**STAFF REPORT: JULY 13, 2022 MEETING**

**APPLICATION NUMBER: 22-7906**

**ADDRESS: 1659 LONGFELLOW**

**HISTORIC DISTRICT: BOSTON EDISON**

*1980 appearance of side bumpout*

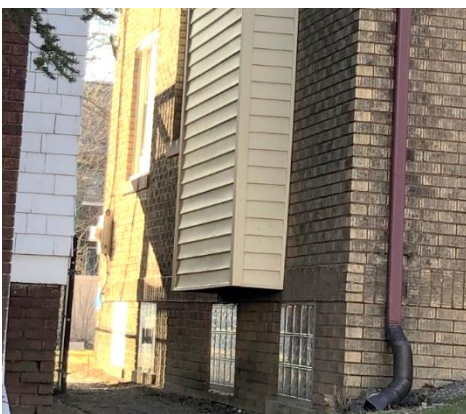
- The close-up of the below 1980 photo shows the original exterior wall cladding of brick, stucco, and tile created a cohesive design to the structure through material, pattern and color. The stucco on the side projecting bay creates a textural relief against the pattern of the brick and tiled dormer walls. Projecting bays on side walls near the front elevation are a common design feature in the Boston-Edison district. It is staff’s opinion this element is a distinctive character-defining feature of the house and district at-large. Commonly covered with stucco with two-to three small (usually decorative) windows, the installation of vinyl siding has significantly altered this feature of the

house. The removal of the windows at this location does not meet the SOI's Standards because it will result in an appearance that more closely resembles a stucco box rather than an integrated design feature/a true bay. Therefore, the windows should be restored. However, staff does support the removal of the siding at this location and the restoration of the stucco which remains beneath.

- New wood windows at the east elevation bump out bay shall be installed to replicate the windows that were removed without approval
